BUILDING AND DEVELOPMENT PERMIT

Civic Address 257 Campion Cres**Scope of Permit** Addition and Conversion to O.U.D. w/Secondary Suite

**Re: Building Permit Application BAP# 3386/21
257 Campion Cres, Saskatoon
Addition and Conversion to O.U.D. w/Secondary Suite**

1 SITE PLAN
3/64" = 1'-0"

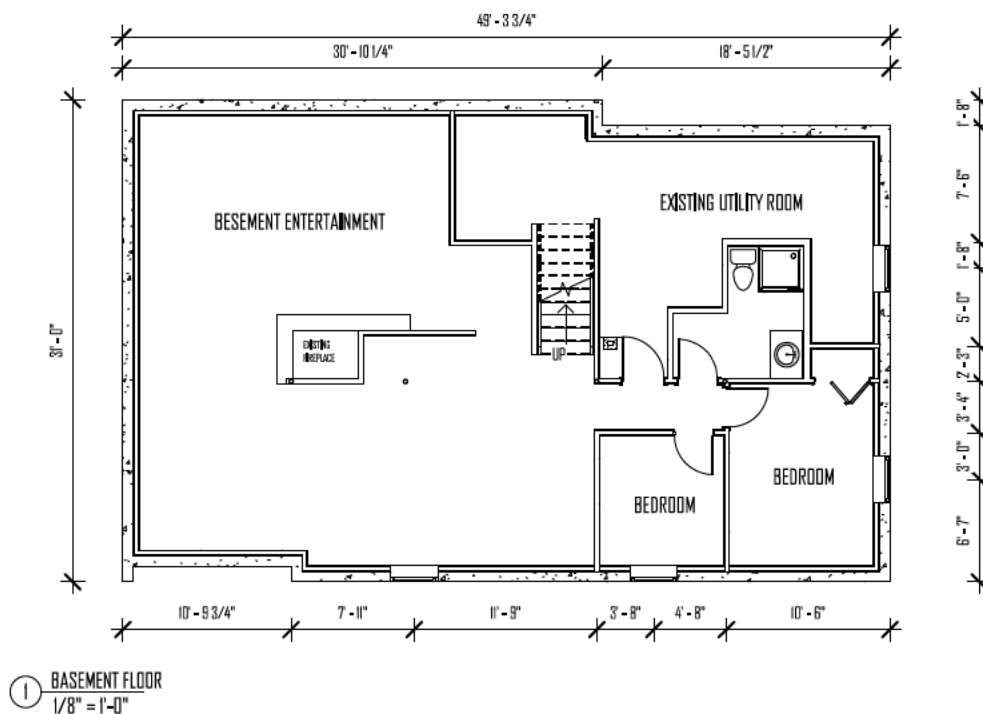
Soffits not permitted within 0.45m (18") of property line
